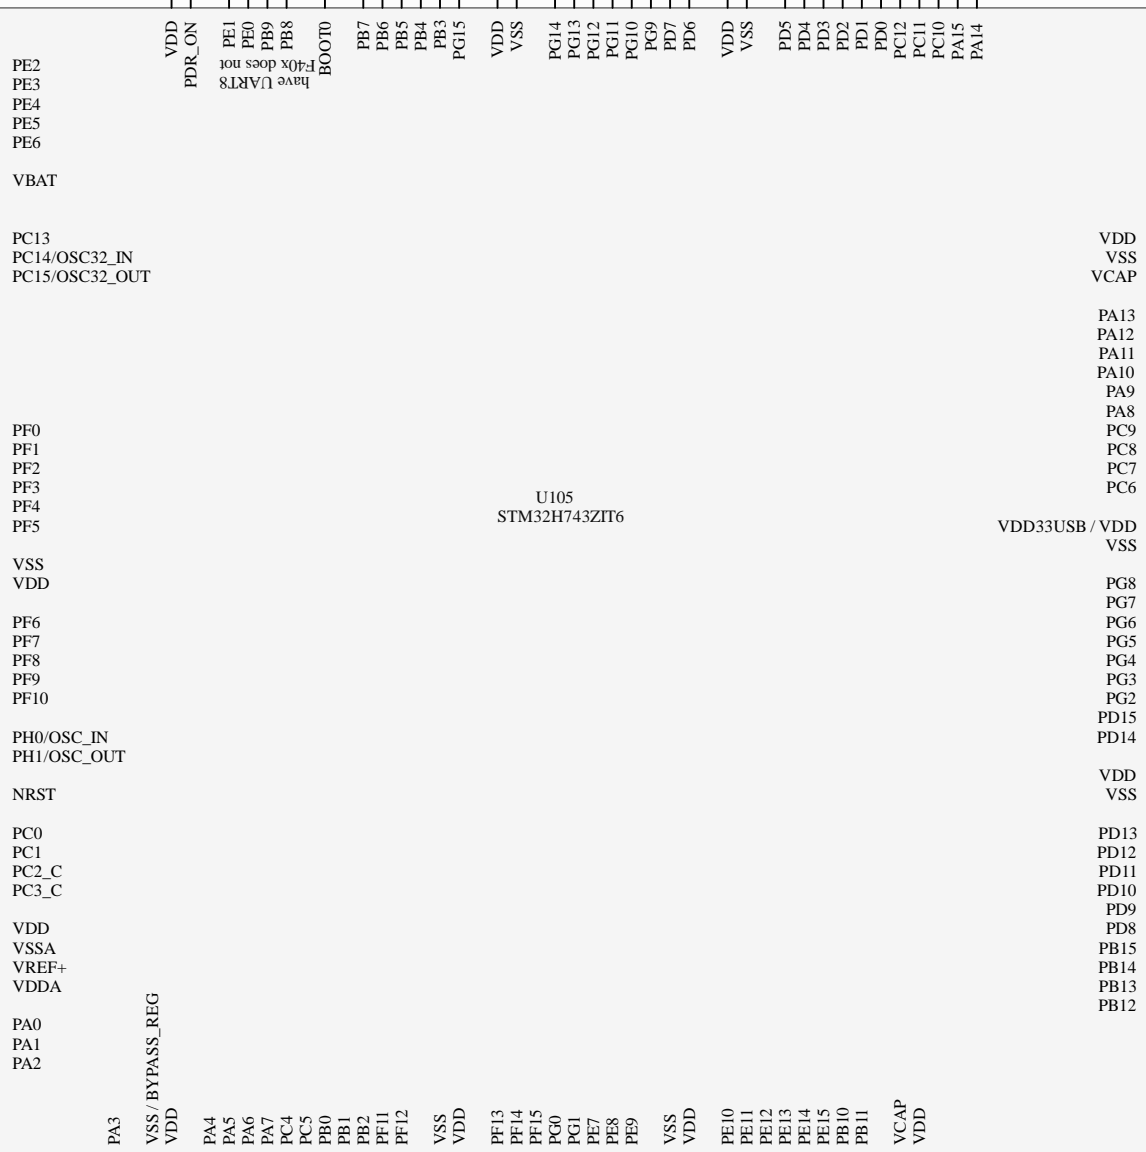
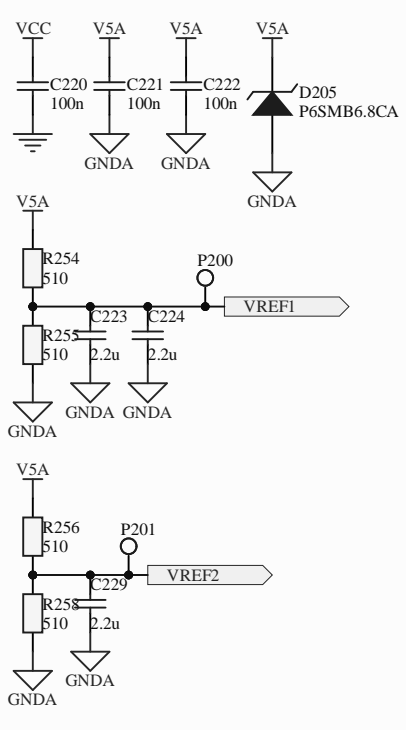
*A20-A23 are duplicated for ADC3
 *VIGN input is unprotected!
 *D5 is digital-only on F429! (EINT11)
 *A20-A22 are duplicated for COMP1/2

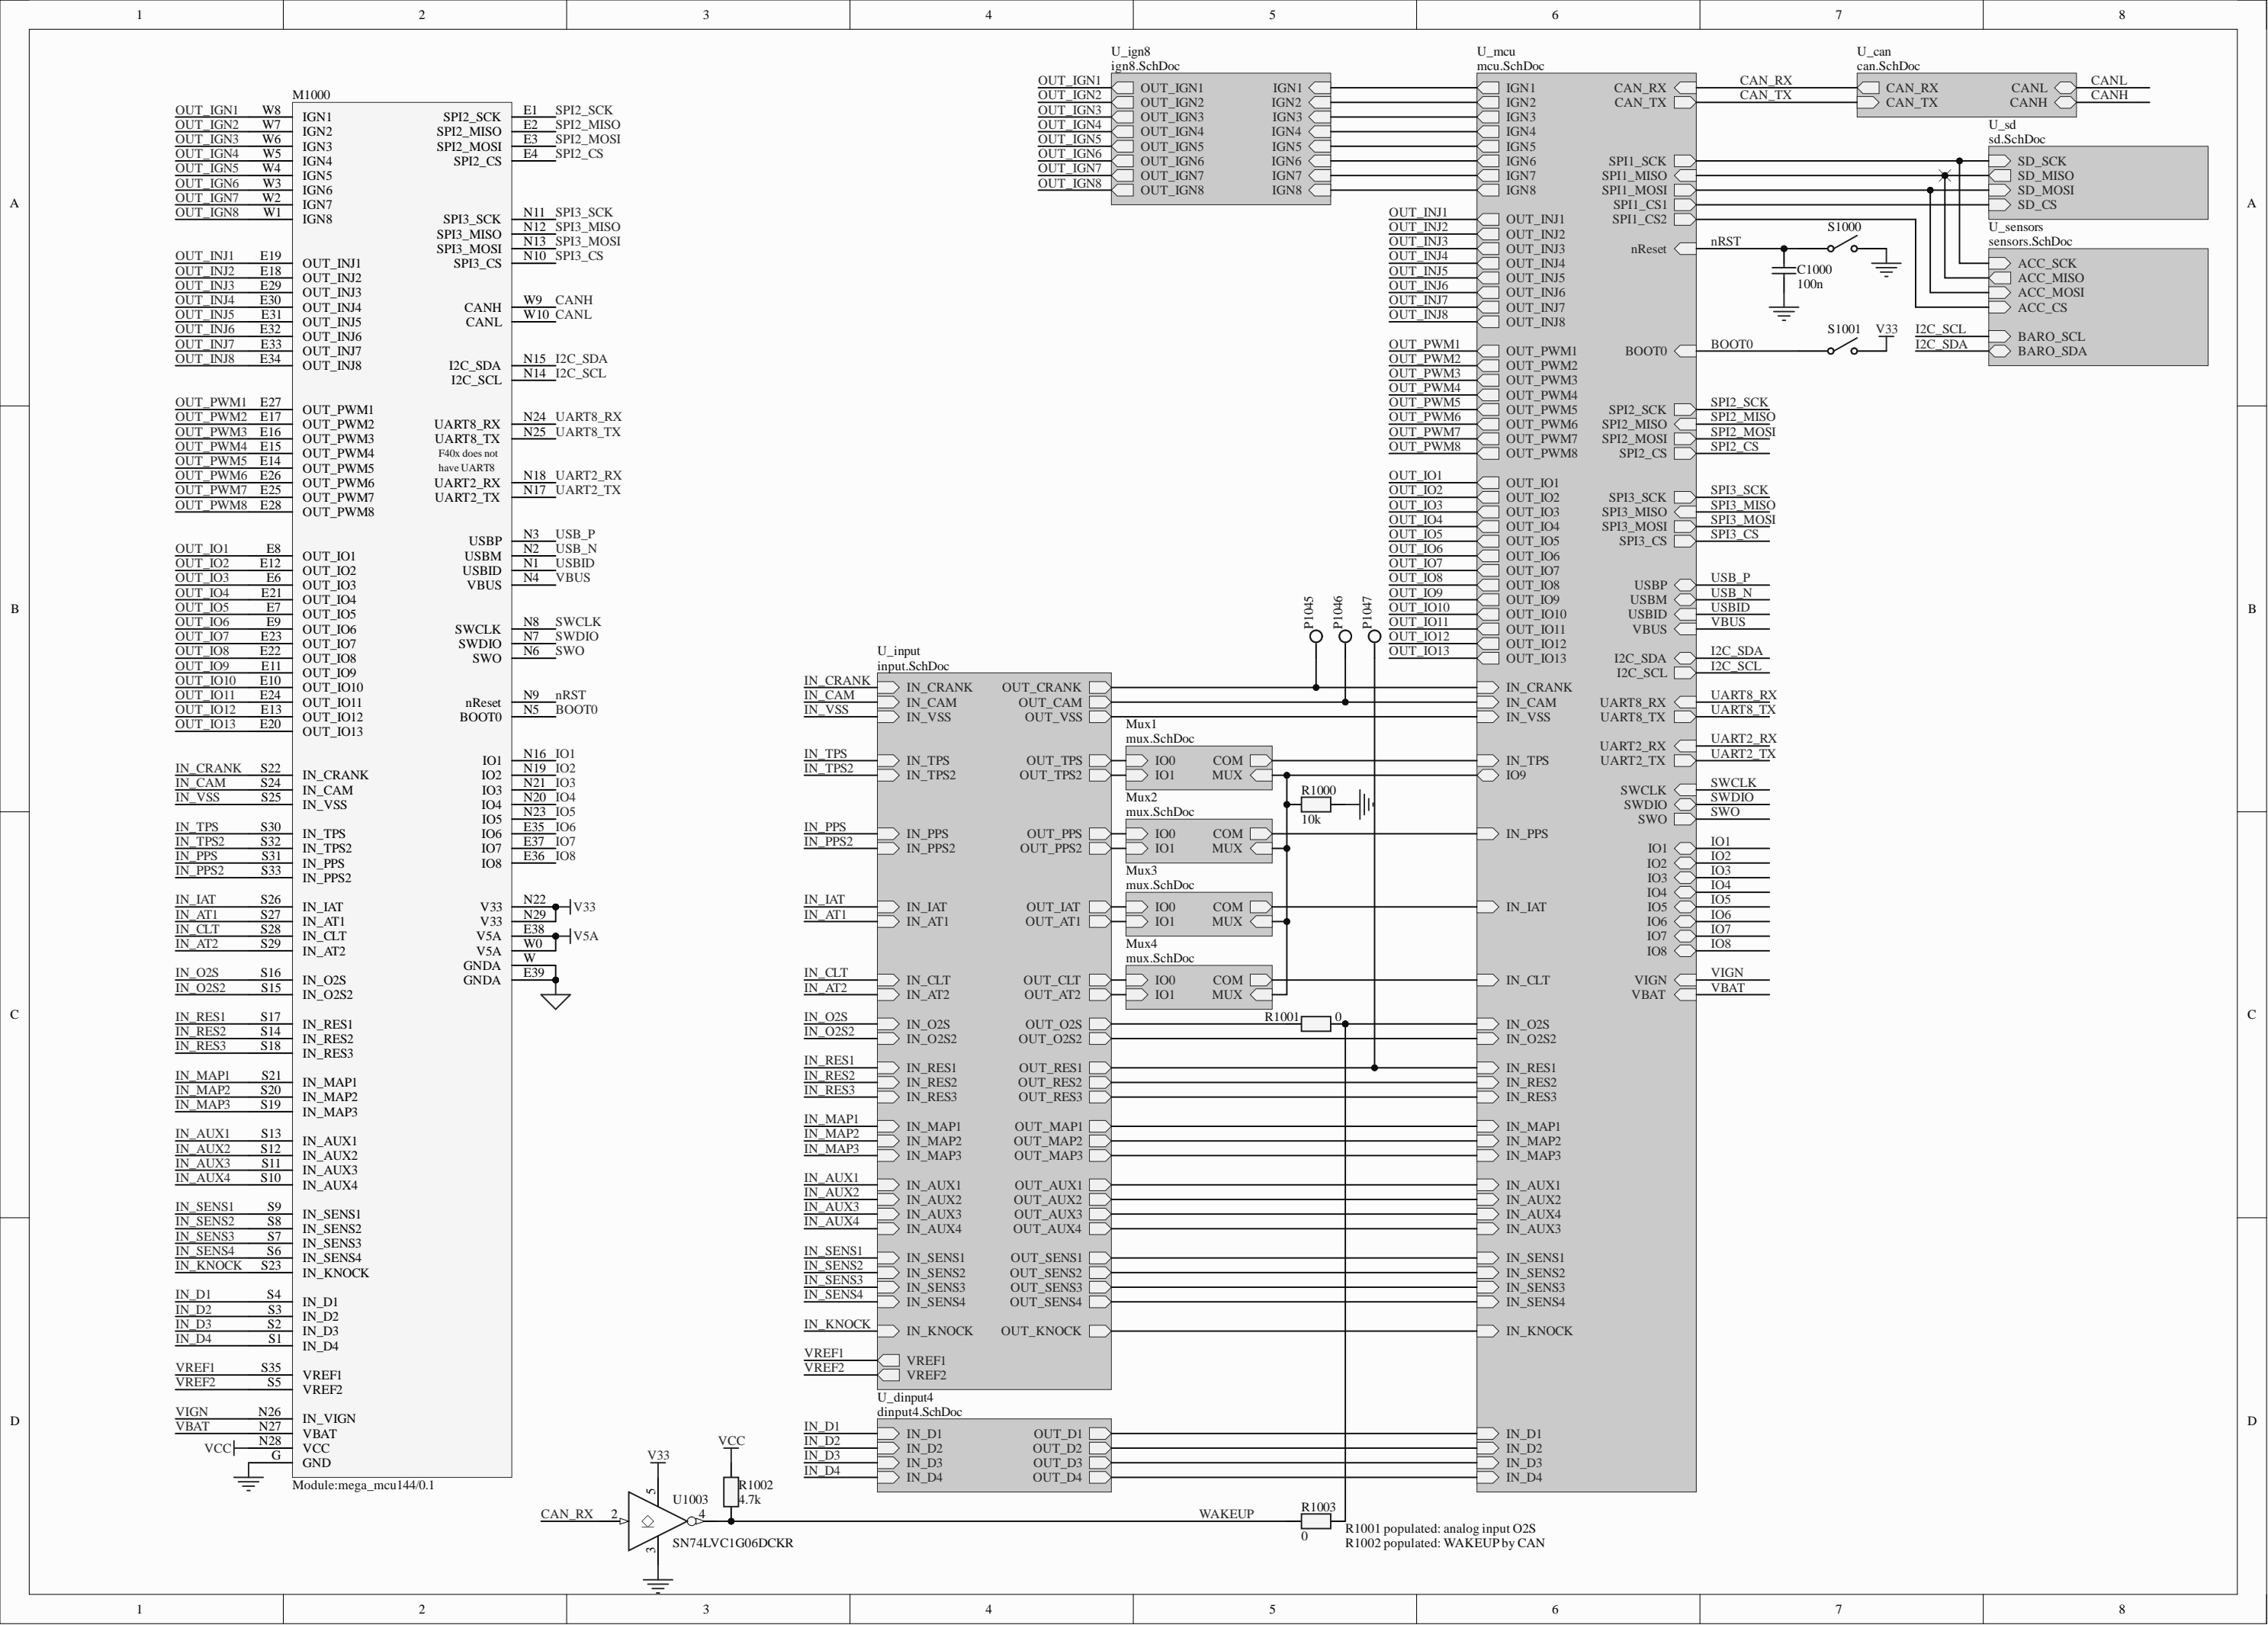
More accurate threshold for "raw" connection of VR sensors
